SUBJECT: Transmittal of Revised Responses to AP1000 DSER Open Items

**AP1000 Design Certification Review
Draft Safety Evaluation Report Open Item Non-Proprietary Responses**

DSER Open Item Number: 19.1.10.1-5 (Response Revision 1)

Figure A3.5-12

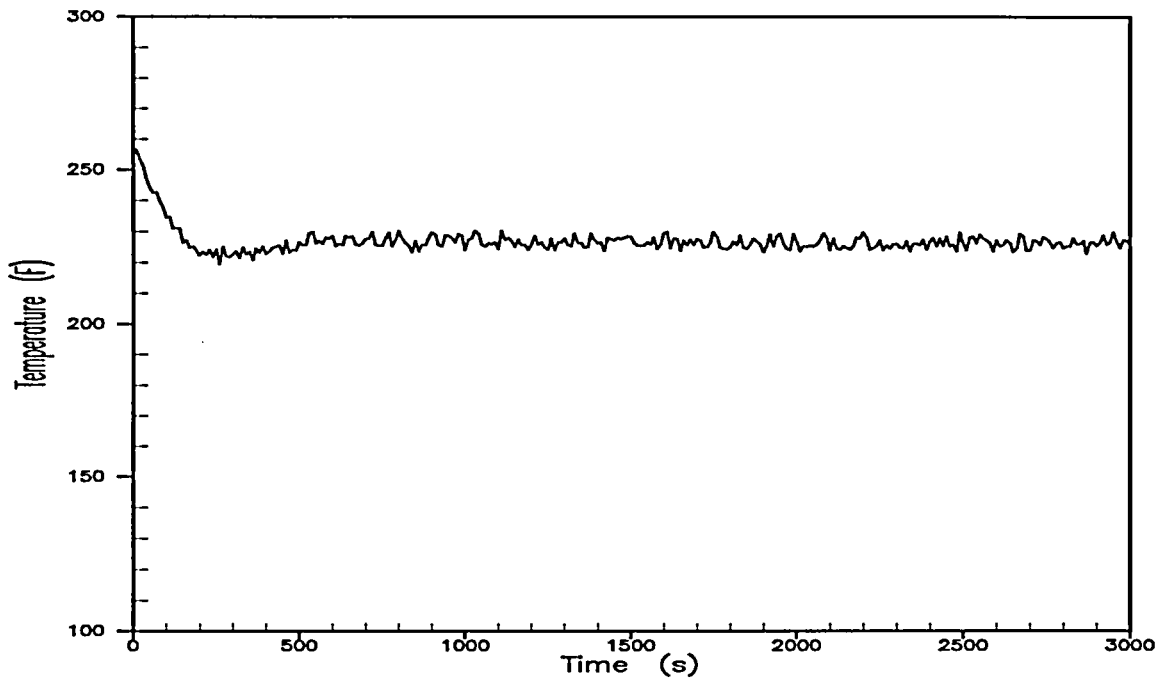
- (f) Additional justification should be provided that sequences which assume failure of one of the four ADS stage #4 valves and also assume failure of containment isolation, will end in successful core cooling (RAIs 720.012, 720.009 and 720.017):

This issue is unresolved. In the revised response to RAI 720.09, Westinghouse presented the results of an analysis using WCOBRA/TRAC with inputs determined from a MAAP4 analysis. The staff has the same issue with this analysis as is stated under Item a. In the revised response to RAI 720.17, Westinghouse argued that this case is not risk significant and therefore it is not necessary to perform a T&H uncertainty analysis. This argument is not valid since OK6 (See Figure 2-4 of RAI 720.012), OK2 and OK4 sequences (on Figure 2-5 of RAI 720.012) fall in this category. Are these OK sequences considered to be low risk?

- (f) The long term cooling success criteria analysis in the revised response to RAI 720.09 (3 of 4 ADS4, containment isolation failure) has now been performed using the revised WCOBRA/TRAC model and using input conditions from WGOTHIC. The revised analysis replaces the previous one as shown below in the revision to PRA Appendix A. This confirms the success criteria for this case. With respect to the statement we made in RAI 720.017 rev 1 about a T&H uncertainty case with 3 ADS-4 valves and failure of containment isolation, we have the following response. Such a sequence is not risk important with the current expanded event trees. The question regarding sequences that we identified as OK sequences with 3 ADS-4 valves and CI failure is a new / different question. These sequences are less severe than the success criteria case in that they have some ADS 2/3 valves opening and have 1 CMT (in addition to 1 Accumulator). The addition of the CMT will compensate for the water lost out of the containment through a failed CI. In addition, these OK sequences have probabilities of ~ E-10 / yr, or less. The highest UC sequence with 3 ADS-4 and failed CI is UC8/sad27, see PRA Appendix A Table A5.1-2. This sequence has a CDF probability of 2 E-10 and is not risk important.

into the downcomer through the DVI break supplements the IRWST injection. As this flow path becomes established, the levels in the downcomer (Figure A3.5-1), the reactor core (Figure A3.5-2), and the upper plenum (Figure A3.5-8) are sufficient to maintain core cooling. The effect of this injection flow increase is also seen in Figures A3.5-3 and A3.5-4, which show a void fraction decrease in the upper half of the core.

The three available ADS Stage 4 valves provide enough venting capacity that adequate depressurization capability exists to achieve successful performance of the passive safety systems (Figures A3.5-9 and A3.5-10). The fuel remains covered throughout the transient, and adequate core cooling is provided to remove the decay heat. The hot rod cladding temperature at the top of the core is slightly above saturation temperature (Figure A3.5-12) throughout the transient.

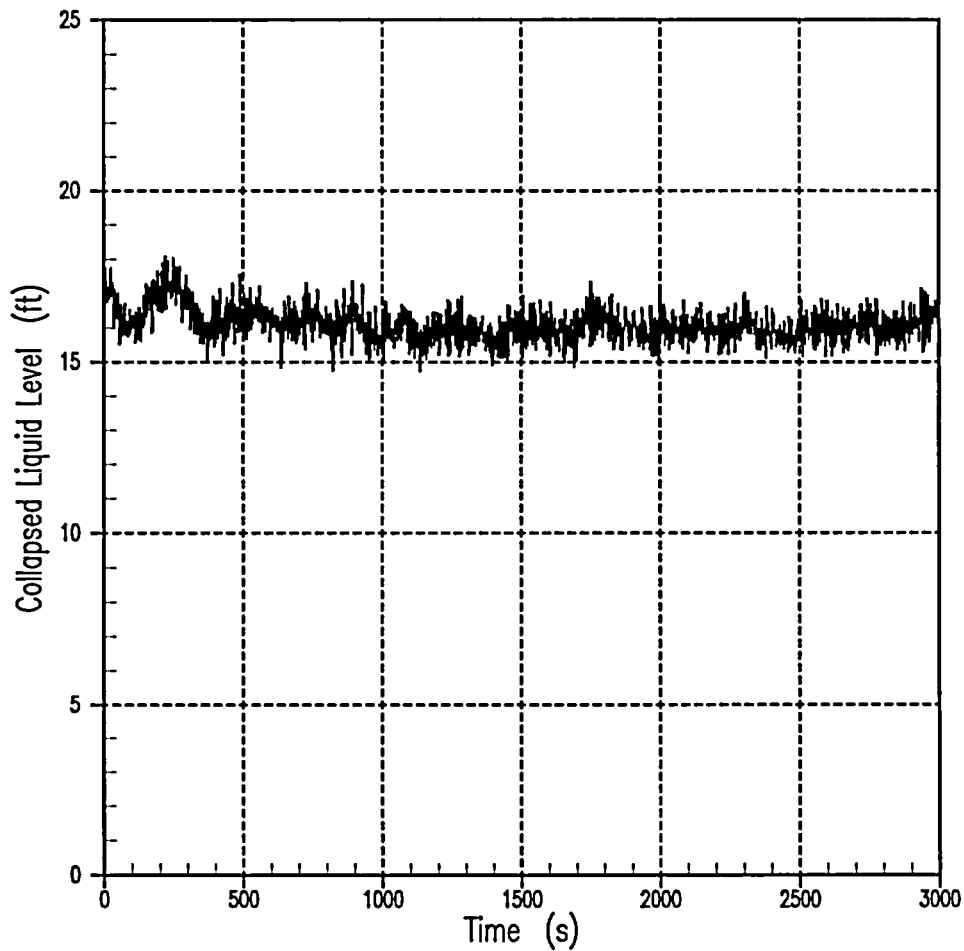
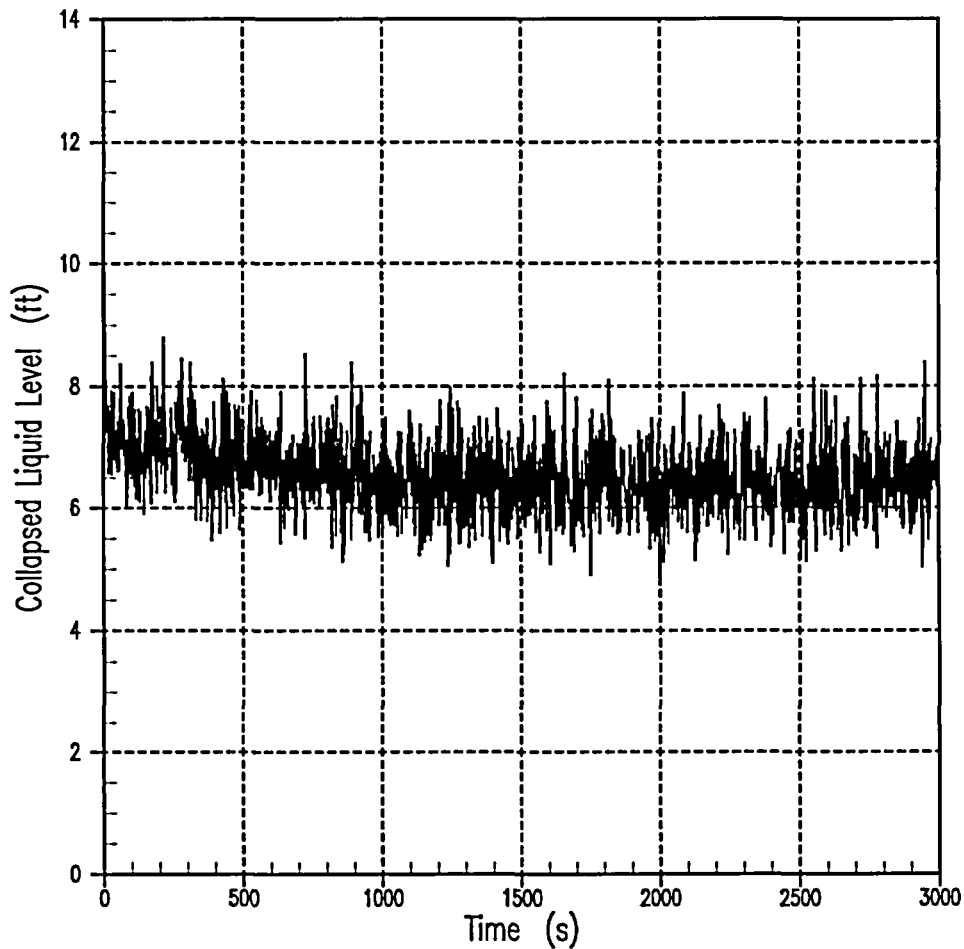
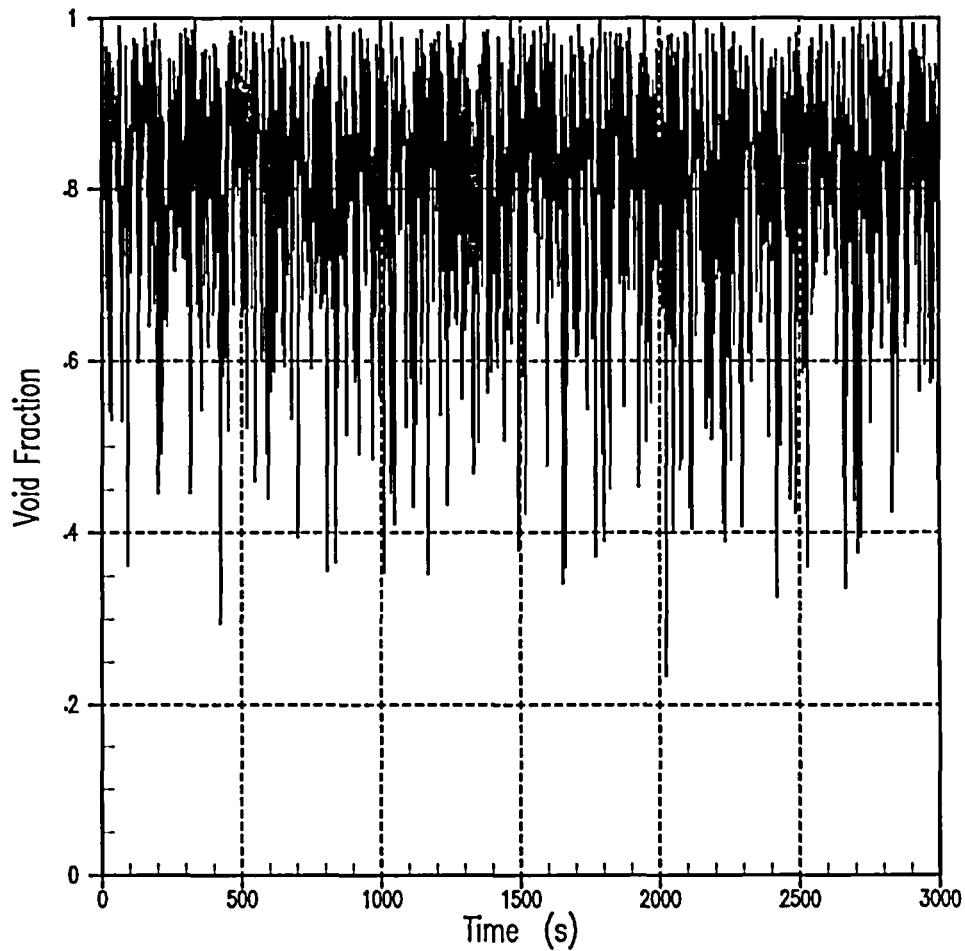
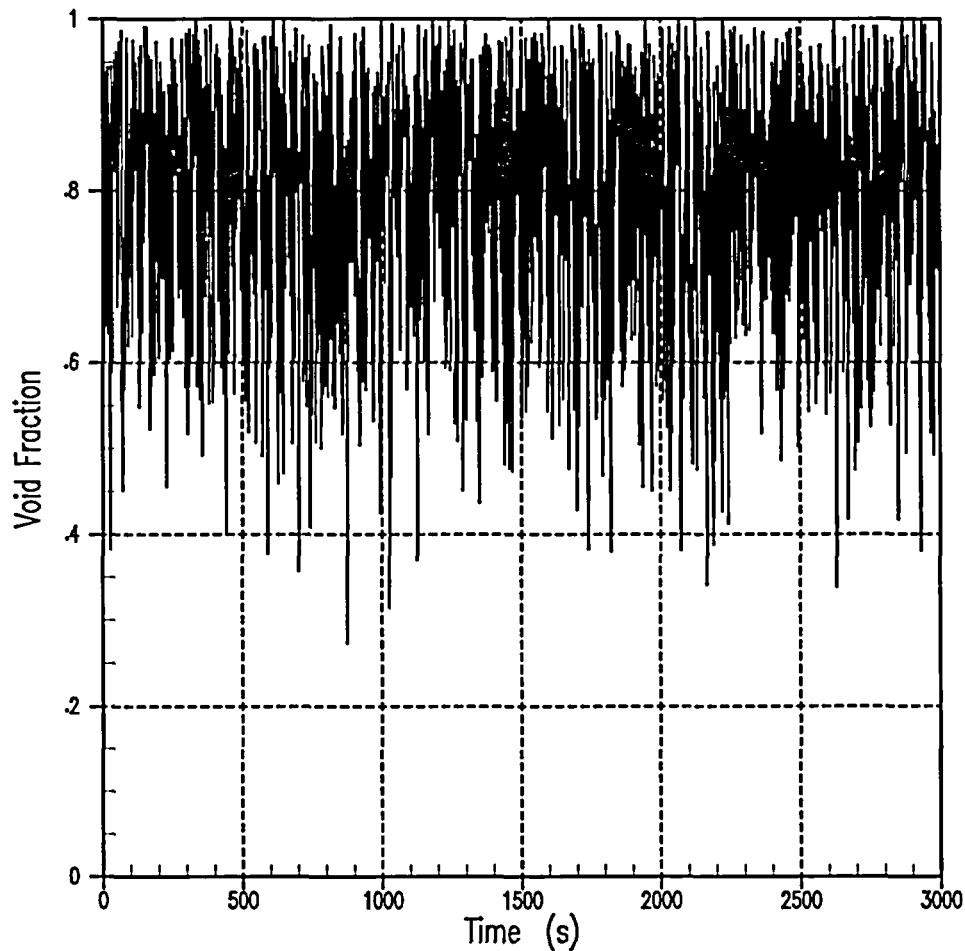
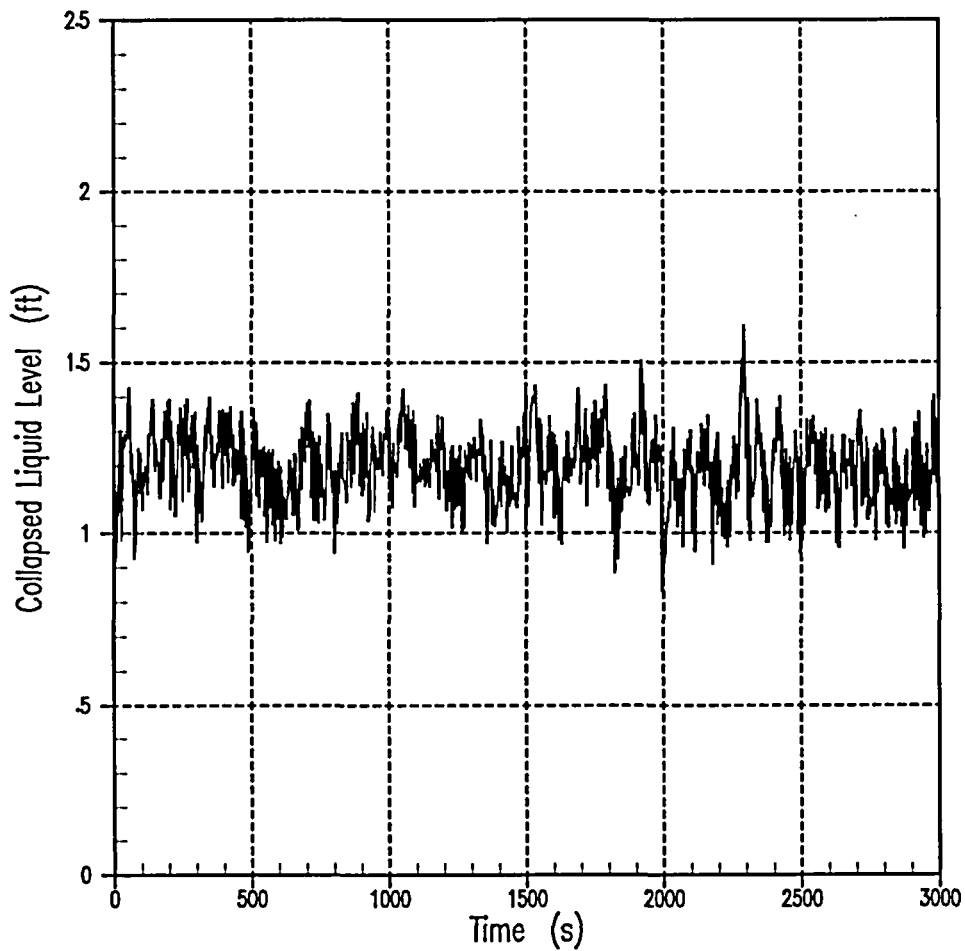
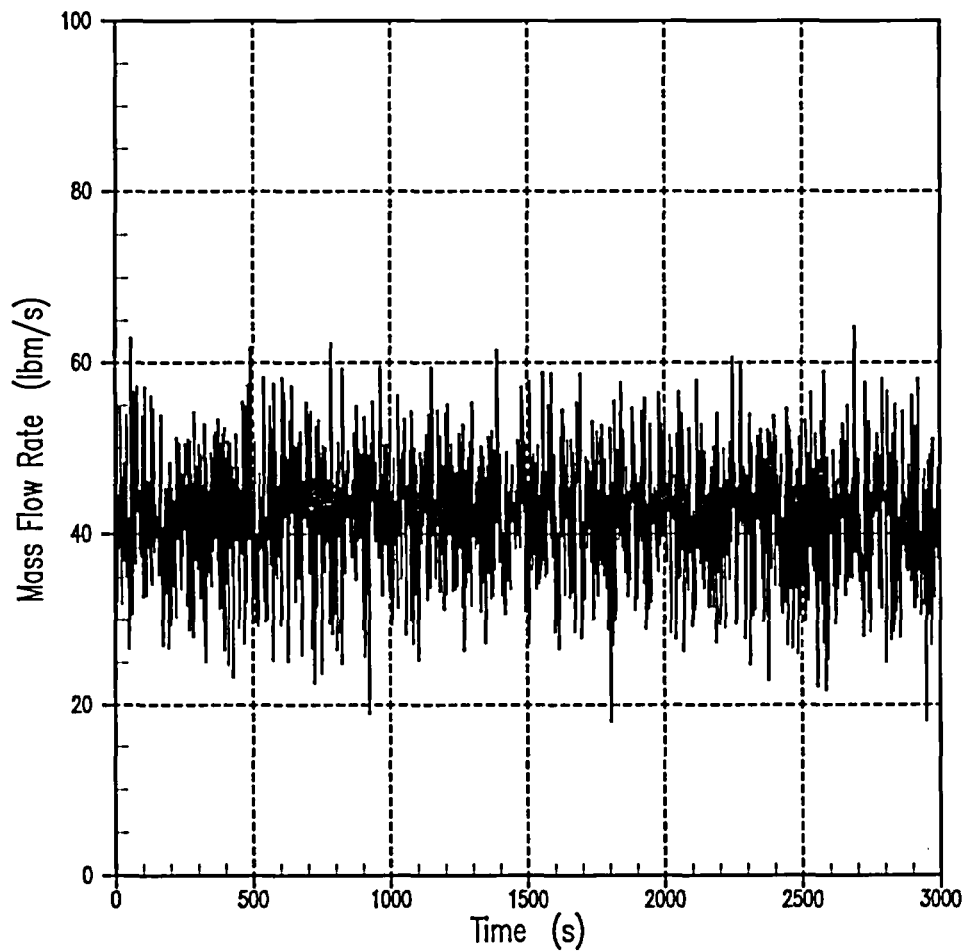
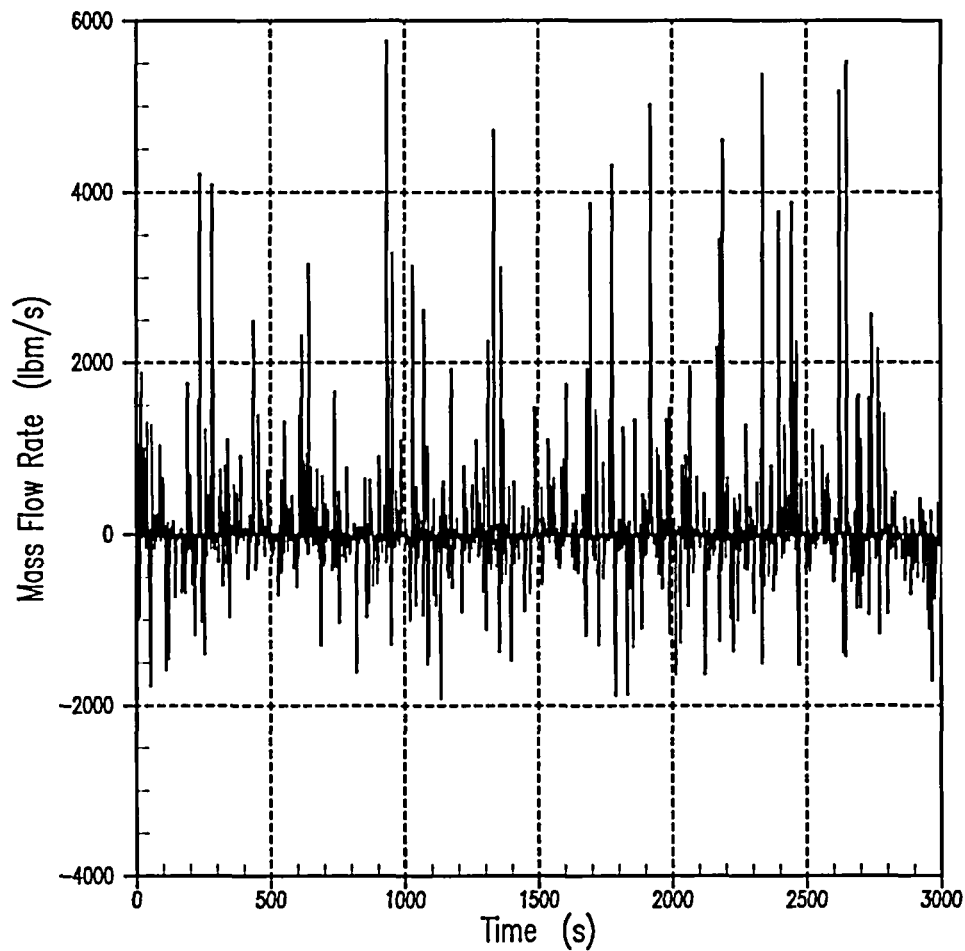
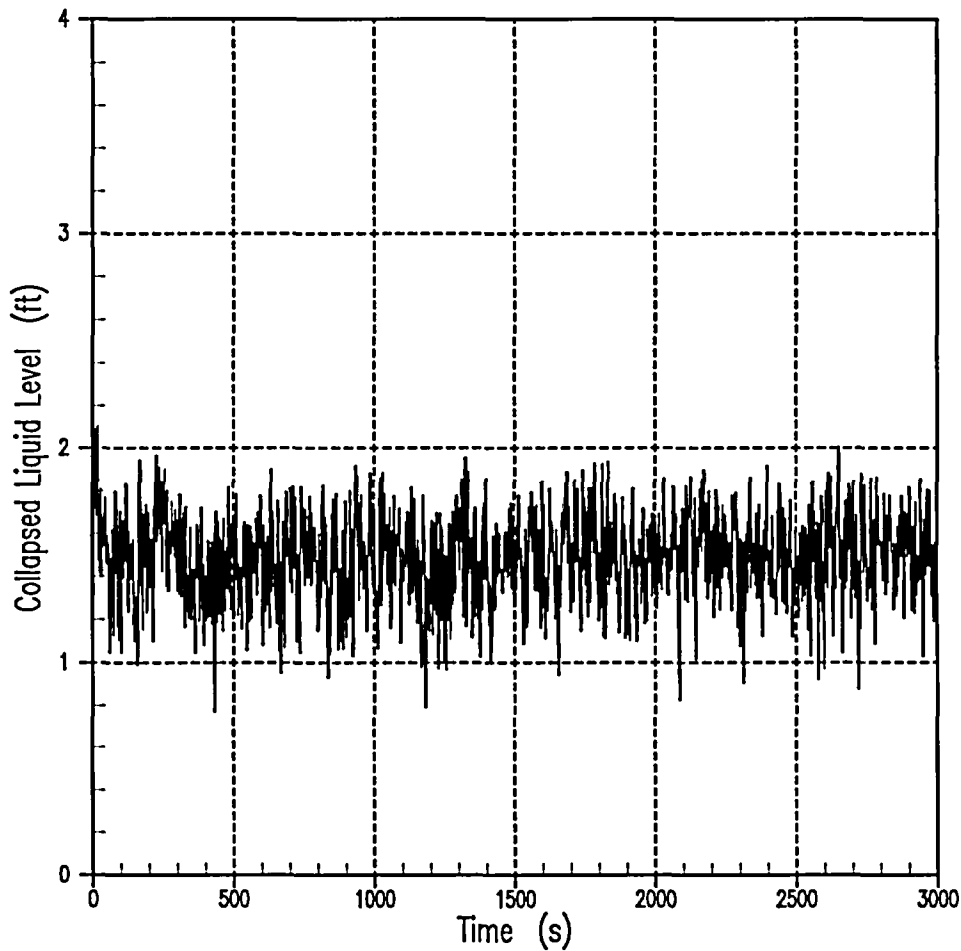
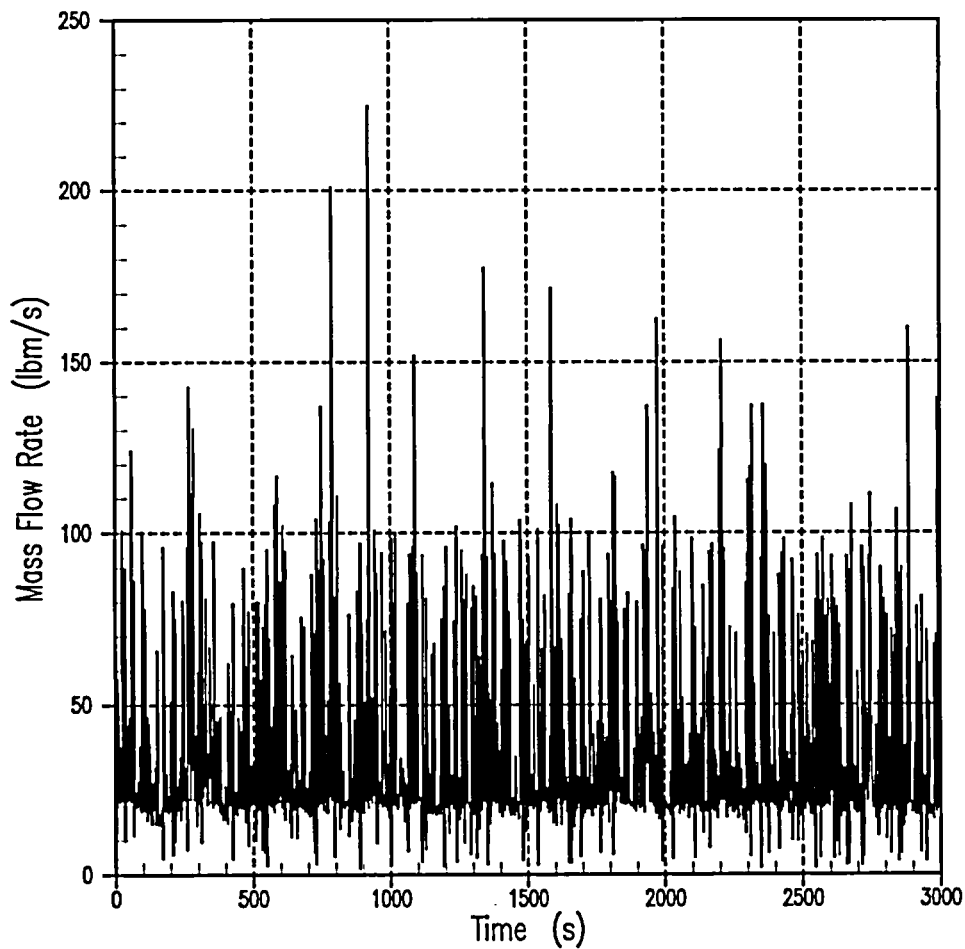
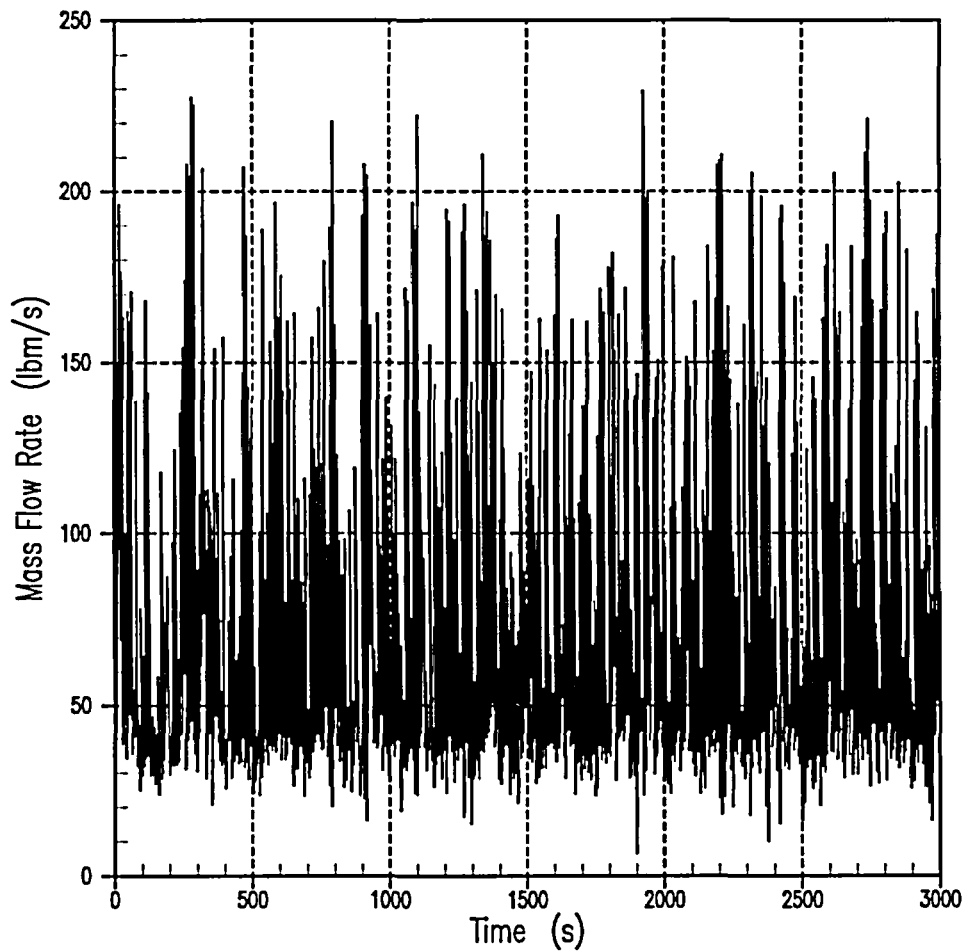
This issue remains open. In the revised response to RAI 720.013, Westinghouse performed long term cooling analyses for bounding conditions in the PRA. (Case F DEDVI, 1 CMT, 1 recirc line, 3/4 ADS4 and CI) and (Case G DEDVI, 1 CMT, 1 recirc line, 4/4 ADS4 and CI failure). The WCOBRA/TRAC code was used for LTC calculations with input conditions derived from MAAP4 analyses. As discussed in the DSER the staff has not reviewed MAAP4 except for its use in screening studies. These are analyses using minimum equipment sets as discussed in the DSER. The staff believes that only a methodology the staff has reviewed should be utilized. In addition, as a result of staff and ACRS questions, the WCOBRA/TRAC long term cooling model has been changed. The staff believes that the revised model should be used in these bounding calculations.

- (a) The long term cooling success criteria analysis case and the thermal hydraulic uncertainty cases F and G have now been performed using the revised WCOBRA/TRAC model and using input conditions from WGOETHIC. The revised cases replace the previous cases as shown below in the revision to PRA Appendix A.

momentarily, faster depressurization occurs at about 2.05 hours into the transient (Figure A5.3-11). Consequently, the IRWST injection is increased even further, and as a result, the levels in the downcomer (Figure A5.3-1), the reactor core (Figure A5.3-2), and the upper plenum (Figure A5.3-8) are also increased. The effect of this injection flow increase can also be seen on Figure A5.3-4, which shows a sharp void fraction decrease in the upper half of the fuel region adequate to maintain acceptable core cooling.

The available three out of four ADS Stage 4 valves provide enough venting capacity to assure adequate depressurization and successful performance of the passive safety systems (Figures A5.3-9 and A5.3-10). The fuel remains covered throughout the transient and adequate core cooling is provided to remove the decay heat. The hot rod cladding temperature at the top of the core is about 20°F above saturation (Figure A5.3-12) and is steadily decreasing exhibits no excursions.
